Date: May 02, 2001

From: George Penokie (Tivoli Systems)

Subject: Defining Targets/Initiators as Ports

The following show the changes in SAM-2 that would be required to change to support a port = target/initiator model.

Figure 8 — Target/Initiator model

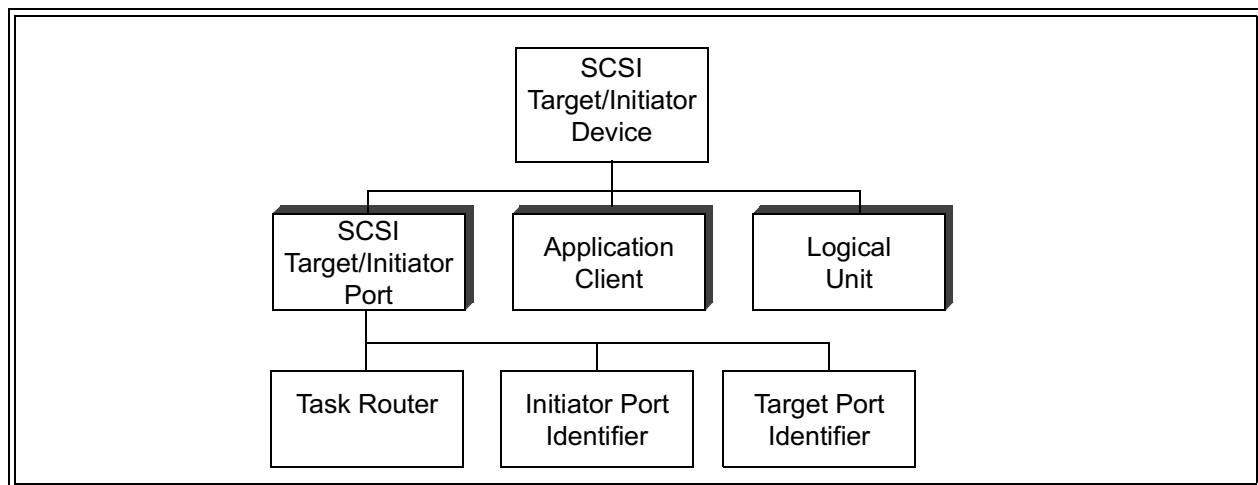
New SAM-2 section 4.7.3 SCSI target/initiator device

A SCSI target/initiator device (see figure 7) contains:

- a) one more SCSI target/initiator ports each containing a task router, target port identifier, and an initiator port identifier;
- b) one or more logical units; and
- c) zero or more application clients.

Figure 10 — SCSI device functional models

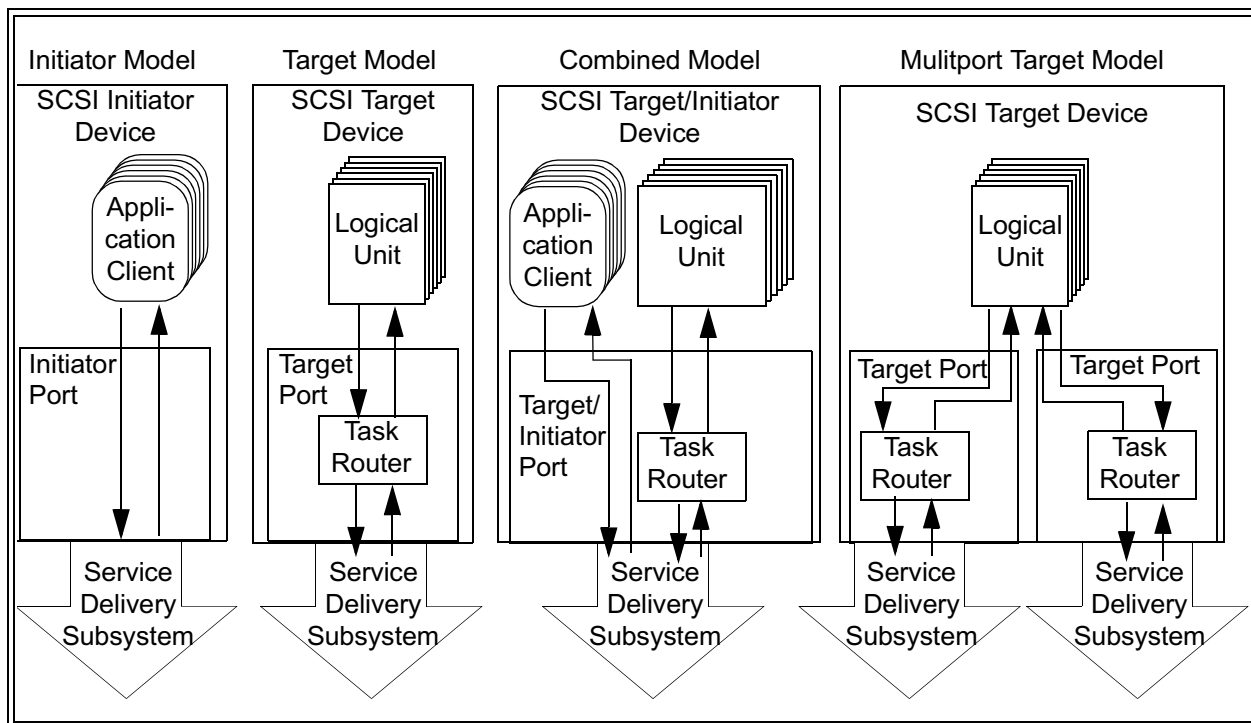
A SCSI device may contain only SCSI target ports, only SCSI initiator ports, only SCSI target/initiator ports or any combination of ports. Some of the port configurations possible for a SCSI device are shown in figure 10.

A target/initiator SCSI device is referred to by the role it's port takes when it participates in an I/O operation. When a SCSI target/initiator device receives SCSI commands or task management functions, the SCSI target/initiator device takes on the characteristics of and is referred to as a SCSI target device. When a SCSI target/initiator device issues SCSI commands or task management functions, the SCSI target/initiator device takes on the characteristics of and is referred to as a SCSI initiator device.

Figure 11 — Multiple port target SCSI device structure model

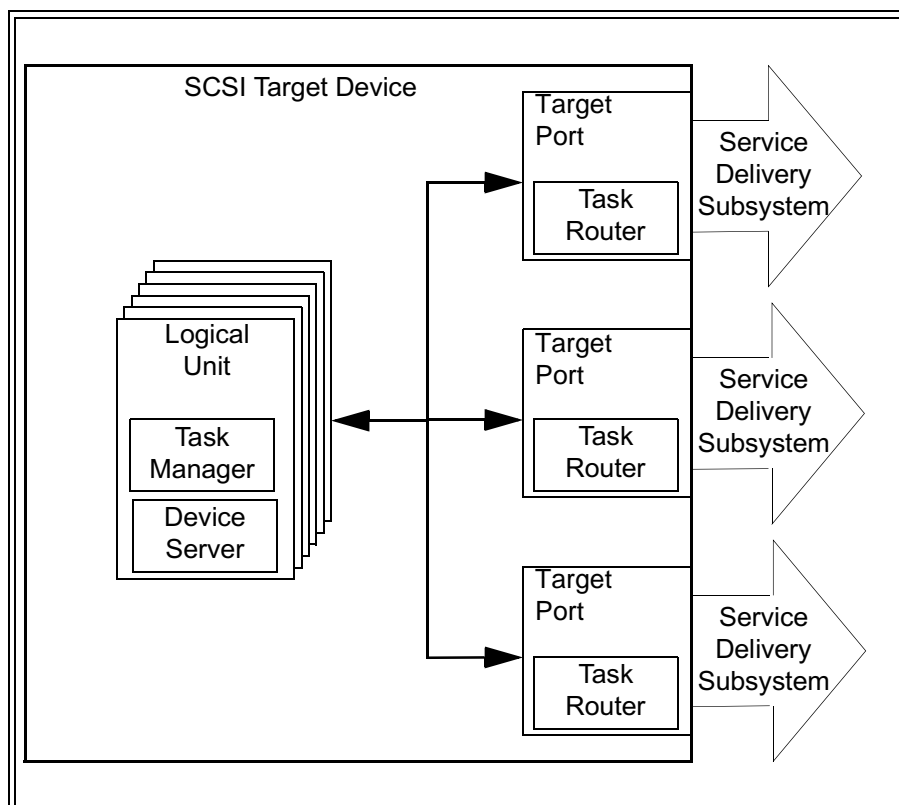
New SAM-2 section 4.11.2 Multiple port target SCSI device structure

Figure 11 shows the structure of a SCSI target device with multiple SCSI target ports. Each SCSI target port consists of a task router that is shared by a collection of logical units. Each logical unit contains a single task manager and a device server.

Two-way communications shall be possible between all logical units and all SCSI target ports, however, communications between any logical unit and any SCSI target port may occasionally be inactive. Two-way communications shall be available between each task manager and all task routers. Each SCSI target port shall accept commands sent to LUN 0 and the task router shall route them to a device server for

Figure 12 — Multiple port SCSI initiator device structure model

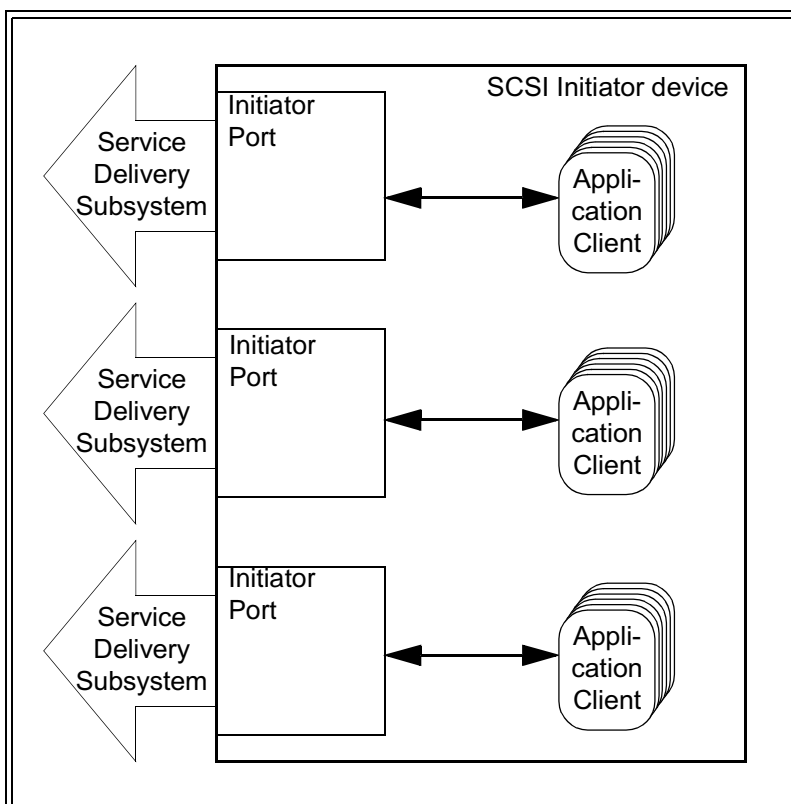
New SAM-2 section 4.11.3 Multiple port initiator SCSI device structure

Figure 11 shows the structure of a SCSI initiator device with multiple SCSI initiator ports. Each SCSI initiator port is shared by a collection of application clients.

Two-way communications shall be possible between an application client and its associated SCSI initiator port. Mechanisms by which a SCSI target device would have the ability to discover that it is communicating with multiple ports on a single SCSI initiator device are beyond the scope of any standards in the SCSI family of standards.

Figure 13 — Multiple port target/initiator SCSI device structure model

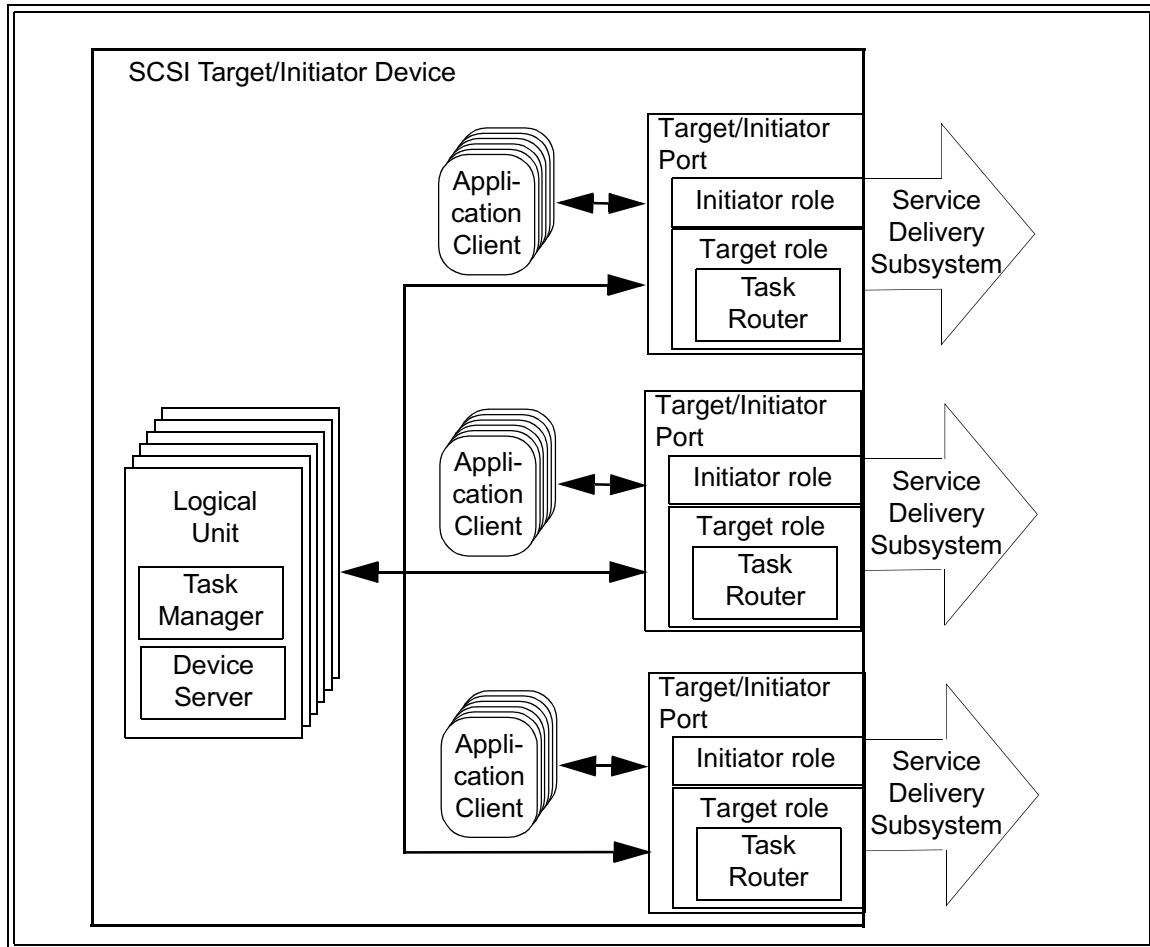
New SAM-2 section 4.11.4 Multiple port target/initiator SCSI device structure

Figure 11 shows the structure of a SCSI target/initiator device with multiple SCSI target/initiator ports. Each SCSI target/initiator port consists of a task router and is shared by a collection of logical units and application clients. Each logical unit contains a single task manager and a device server.

Two-way communications shall be possible between all logical units and all SCSI target/initiator ports, however, communications between any logical unit and any SCSI target/initiator port may occasionally be inactive. Two-way communications shall be possible between an application client and its associated SCSI target/initiator port. Each SCSI target/initiator port shall accept commands sent to LUN 0 and the task router shall route them to a device server for processing. The REPORT LUNS commands (see SPC-2) shall be accepted by logical unit 0 from any SCSI target/initiator port and shall return the logical unit inventory available via that SCSI target/initiator port. The availability of the same logical unit through multiple SCSI target/initiator ports is discovered by matching SCSI port identifier values in the INQUIRY command vital product data page (see SPC-2).

Figure 14 — SCSI target device configured in a single SCSI Domain

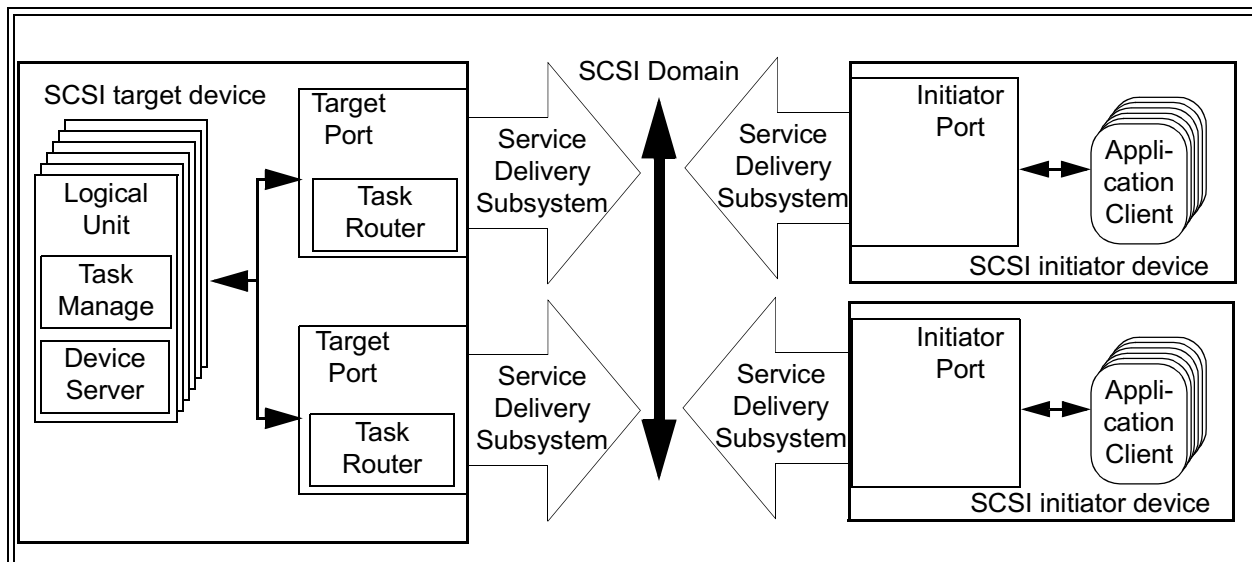
Figure 14 shows a SCSI target device with multiple SCSI target ports participating in a single SCSI domain with two SCSI initiator devices. There are three SCSI devices, one of which has two SCSI target ports, one with one SCSI initiator port, and one with one SCSI initiator port. There are two SCSI target port identifiers and two initiator port identifiers in this SCSI domain. Using the INQUIRY command vital product data page (see SPC-2), the application clients in each of the SCSI initiator devices have the ability to discover the logical units in the SCSI target devices are accessible via multiple SCSI target port identifiers (i.e., SCSI target ports) and map the configuration of the SCSI target devices.

Figure 15 — SCSI target device configured in multiple SCSI Domains

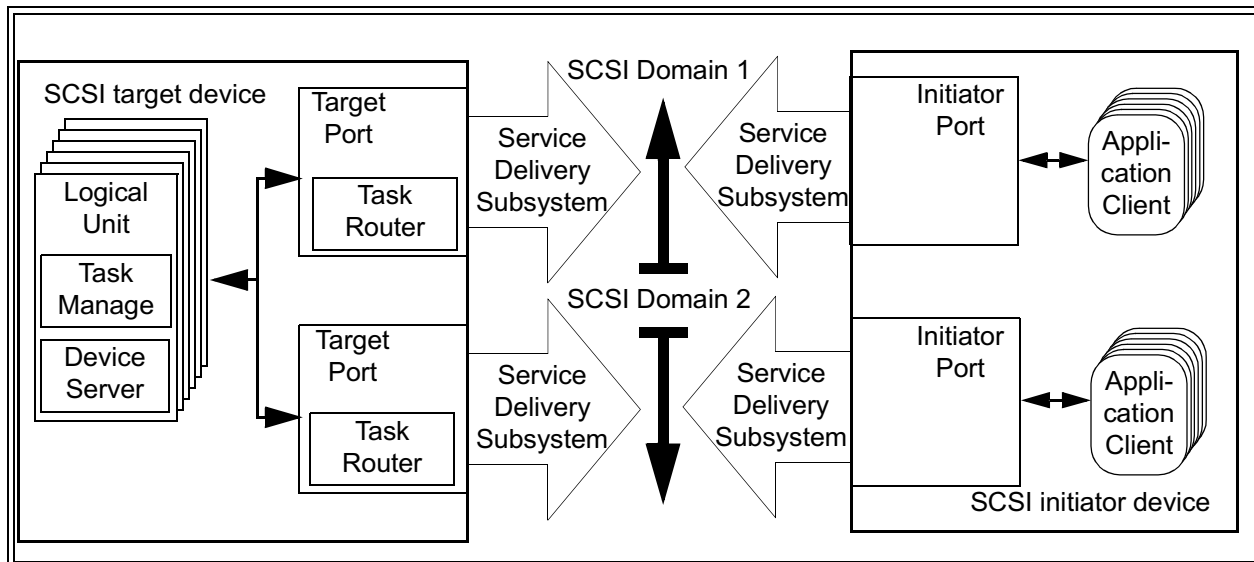
Figure 15 shows a SCSI target device with multiple SCSI target ports participating in two SCSI domains and a SCSI initiator device with multiple SCSI initiator ports participating in the same two SCSI domains. There is one SCSI target device with two SCSI target ports and one SCSI initiator device with two SCSI initiator ports. There is one SCSI target port identifier and one initiator port identifier in each of the two SCSI domains. Using the INQUIRY command vital product data page (see SPC-2), the application clients in the SCSI initiator device have the ability to discover that logical units in the SCSI target device are accessible via multiple ports and map the configuration. However, the methods available to application clients to distinguish between the configuration shown in figure 15 and the configuration shown in figure 14 are beyond the scope of the SCSI family of standards.

Figure 16 — SCSI target device and SCSI initiator device configured in a single SCSI Domain

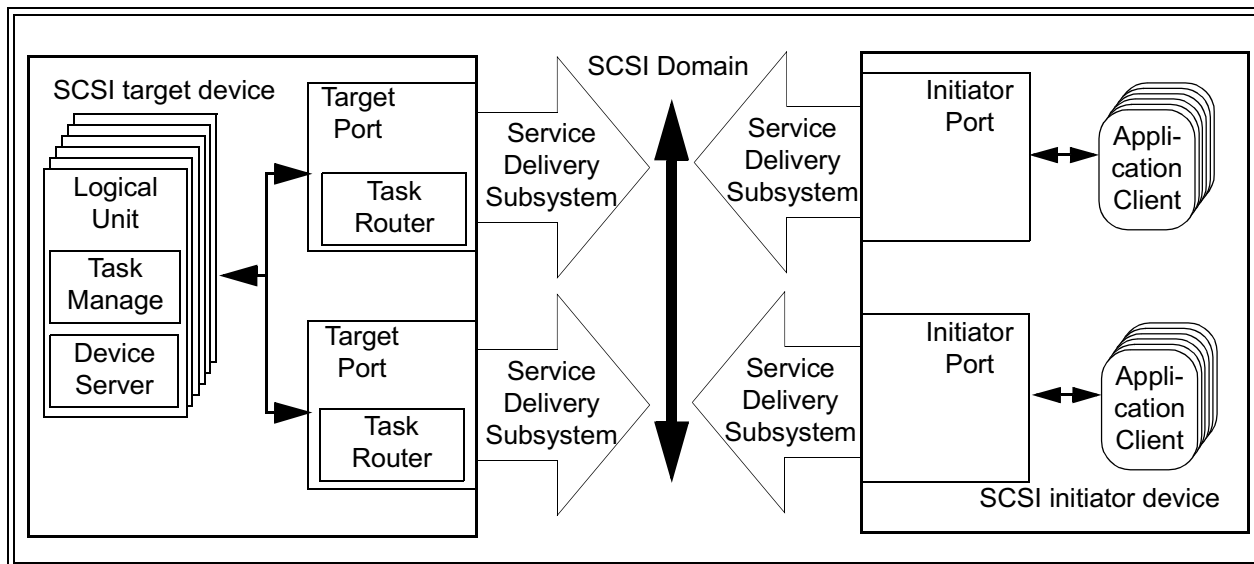
Figure 16 shows the same configuration as figure 15 except that the two SCSI domains have been replaced by a single SCSI domain.
